# **SIX COUNTY SC LIDAR QUALITY ASSURANCE**

## **AIKEN COUNTY FINAL REVIEW**

**UNITED STATES GEOLOGIC SURVEY  
AND  
SOUTH CAROLINA DEPARTMENT OF NATURAL RESOURCES**

Final Review: February 6, 2013

*Figure 2: Overall project flight line exhibit (left) and enlarged view (right)*

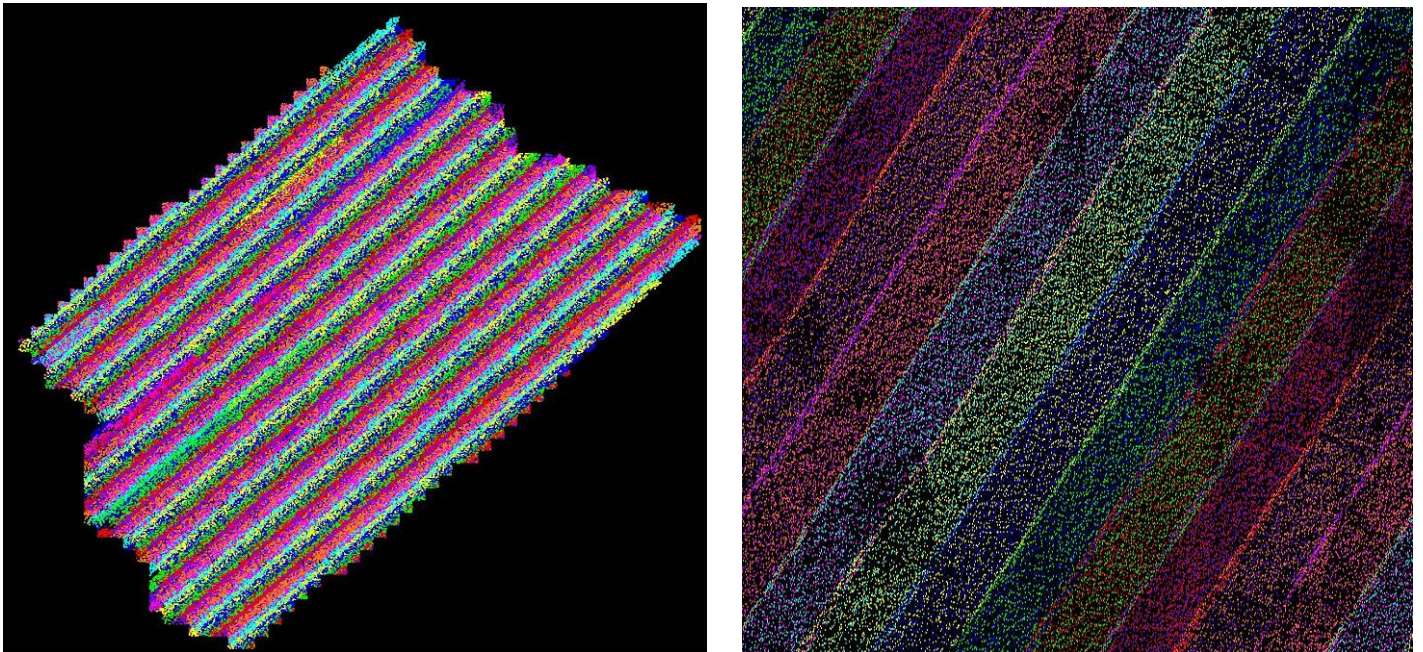
The first item outlined in the Criteria states that flightlines are directed to be flown as planned with 45% minimum overlap between flight lines and a maximum flying height of  $\approx 8,300$  ft AMT. According to the metadata, the flight lines were flown with a sidelap of 50% with a target altitude of 1,500 meters (4920') and based on the stated flight parameters meet the criteria. Additionally, the Positional Dilution of Precision (PDOP) needed to be less than 4, and the collected data could not have holidays and were required to have periodic and local calibration checks. The figures below show the extents of overlap:

*Figure 11: GPS Forward/Reverse Processing Chart – Day 074B*

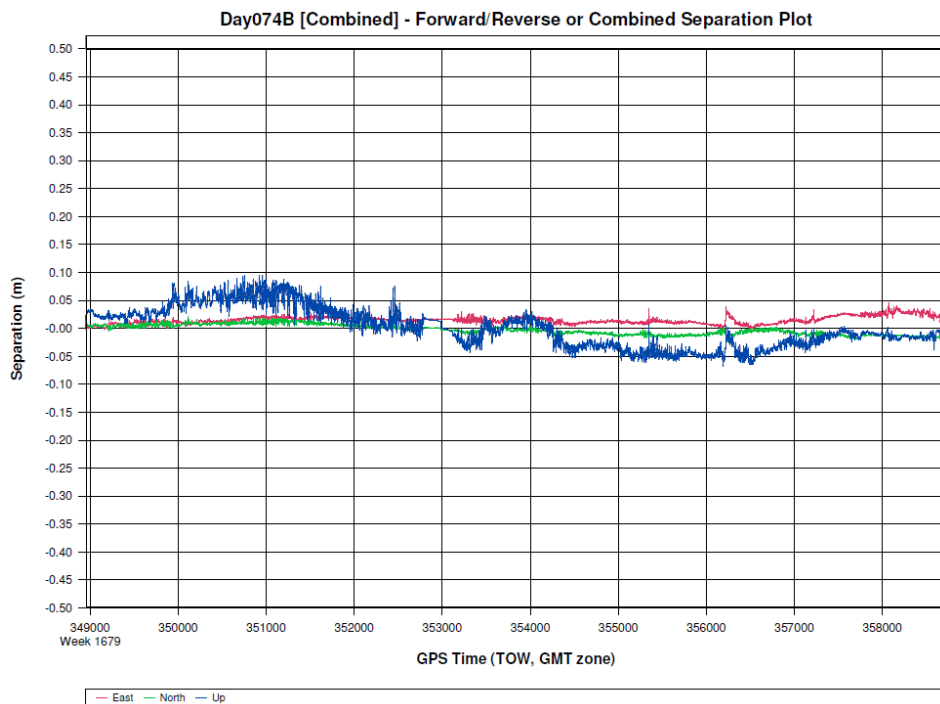
north component of the data. The blue line represents the combined solution of the vertical component of the data. In *figure 11*, it should be noted that the vertical component (blue line) appears to be very noisy and jagged, this is a result of a less dynamic solution of the vertical agreement between the forward and reverse GPS solution of the data. In simple terms the vertical component of the data did not agree as well as in the other *figures (4-11)* but is well within the required tolerances. This is not an indication of an error in the data but representing a difference in the two solutions. Providing, the GPS Combined solution is within tolerance as required this will not affect the overall LiDAR Data.
